East Reading MRT Project Briefing Note

East Reading Mass Rapid Transit

Reference: 622-954

Report of Design Review Meeting

Figure 7 – East Reading MRT – Proposed Design

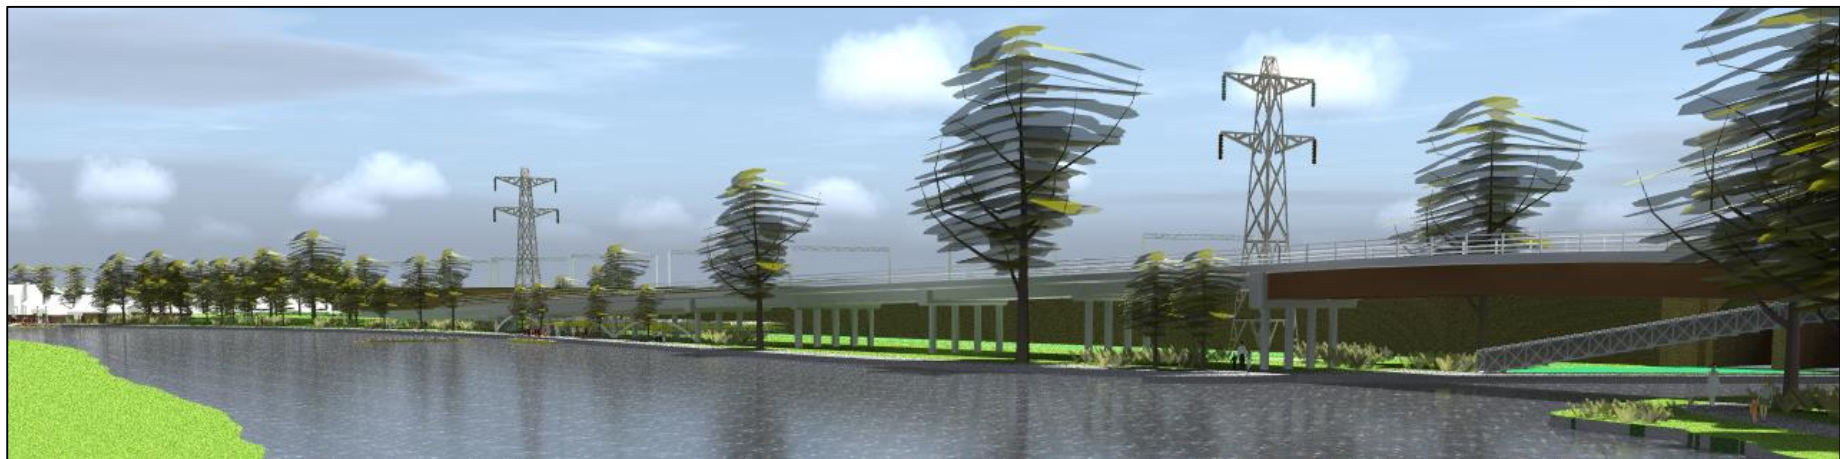
The Panel feel a clear concept for what the viaduct and bridge design aims to achieve is missing. The current proposal outlines constraints, requirements and engineering issues; however, we feel further exploration of potential options and design development is required. The justifications for the selection of one bridge design over the 5 or 6 presented was wholly unconvincing. At present, the proposal is too utilitarian in appearance, and does not successfully achieve the aim of creating a minimal elegant structure. We feel further exploration will be required to decide upon this strategy, relating closely to any landscape and inhabitation strategies. Bridges recently designed for the Olympic Park in Stratford could be a useful source of inspiration in this exercise.

The Panel supported the idea expressed in the material issued for the deck to read as a sinuous element that gently curves in plan and section reflecting the fluid nature of the river and railway line adjacent. This ambition is not currently being supported by the detail of bridge design. A key decision should be whether the raised platform and bridge are read as a continuation of one another, or clearly separated elements. Potential design approaches could include the creation of a continuous minimal 'blade' structure where the platform and bridge would read as a single element with continuous materials used. Structural elements should be minimised wherever possible in this approach, with a predominately steel structure likely to be appropriate to this aesthetic than concrete. Another option could be to create a clearer separation between the raised viaduct and the bridge.

The significance of the listed structure and its curtilage were not fully explored/explained. The Panel were unconvinced that setting the bridge height at 6.7m was preferable to it either being higher (so as not to be visible through the bridge portal to the south) or lower (which would make intermediate connections up/down to the riverside path easier). If part of the significance of the structure is its appearance as a complete 'piece' then a judgement or justification for a particular height, and indeed the bridge's plan position, needs to be made and with reference to agreed key views. The Panel also felt that the possibility of removing the existing 'accommodation bridge', with its function transferred to the new bridge and the narrative history being recorded/presented through interpretation material on the site, had not been explored. Engaging with the fabric of the listed structure in this way might be a means to enhance an appreciation of its significance, and therefore be an opportunity rather than being a risk to the project, as in any case the project will be interacting with the listed structure due to its proximity.

The Panel were critical of the generic design of the column and bearing structures of the bridge/viaduct. These are critical to the look and feel of the undercroft space and are visible along the riverside walk. Alternatives should be explored that achieve the openness and permeability needed for flood reasons but that also relate to the landscape setting (and potential use, or not) of the undercroft, including their sculptural/spatial qualities.
